# Access Compliance Report

Intersection ID: 53517	Main Street: STONEWELLS_DR	Cross Street: KINGAUSSIE_AV	Location: NW
ADA ID: 1F71A27B0236	Ramp Type: BlendTrans1	Initial Pass/Fail: Fail	Overall Compliance: No
		Severity Score: 1.25

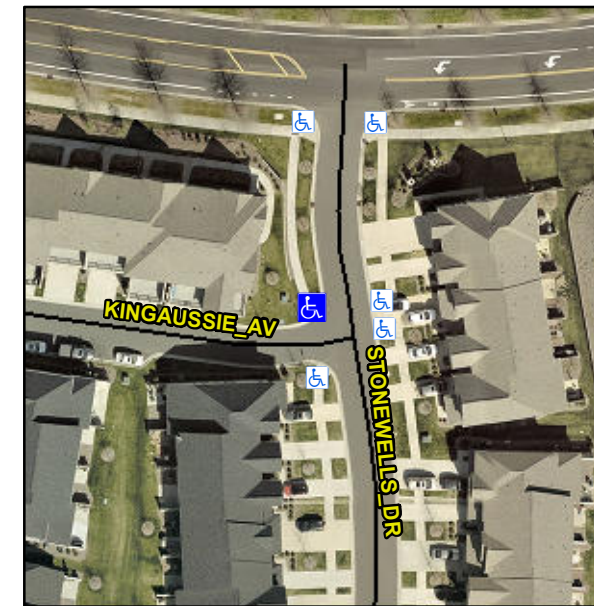
**Not Found, R304.5.3, R304.4.1**

Compliance	Description	Data	Compliance	Description	Data
N/A	Ramp Length (in)	55.0	No	BlendTrans Slope (%)	6.6
Yes	Ramp Width (in)	48.0	No	BlendTrans XSlope (%)	2.9
N/A	Flare Type LT	N/A	N/A	Flare Type RT	N/A
N/A	Flare Slope LT (%)	N/A	N/A	Flare Slope RT (%)	N/A
N/A	Flare Traversable LT?	N/A	N/A	Flare Traversable RT?	N/A
N/A	Landing Length (in)	N/A	N/A	DWS Provided?	N/A
N/A	Landing Width (in)	N/A	N/A	DWS Contrast?	N/A
N/A	Landing Slope (%)	N/A	N/A	DWS Length (in)	N/A
N/A	Landing X Slope (%)	N/A	N/A	DWS Full Width?	N/A
N/A	Landing Curb? (Y/N)	N/A	N/A	DWS Offset (in)	N/A
N/A	Shared Landing?	N/A			
N/A	Gutter Ponding?	N/A	N/A	Gutter Slope (%)	N/A
N/A	Gutter Lip Ht (in)	N/A	N/A	Gutter X Slope (%)	N/A
N/A	Painted X Walk1?	No	N/A	Painted X Walk2?	No
	X Walk 1 Direction	To E		X Walk 2 Direction	To S
	X Walk 1 Width (in)	N/A		X Walk 2 Width (in)	N/A
	X Walk 1 Slope (%)	0.2		X Walk 2 Slope (%)	0.3
	X Walk 1 X Slope (%)	4.0		X Walk 2 X Slope (%)	2.9

N/A	Ramp inside XWalk1?	N/A	N/A	Ramp inside XWalk2?	N/A
	Road Slope (%)	4.0		Clear Space?	N/A
	Road X Slope (%)	0.1	N/A	Clear Space to XWalk (in)	N/A
N/A	Any Obstructions?	N/A	N/A	Storm Grate/Utility Hazard?	N/A
	Obstruction Type			Storm Grate/Utility Type	
		N/A			N/A
			Yes	Surface Condition? (G/P)	Good
			No	Curb Slope (%)	9.4

**Remove & Replace Curb Ramp With Two New Directional Ramps or Equivalent.**
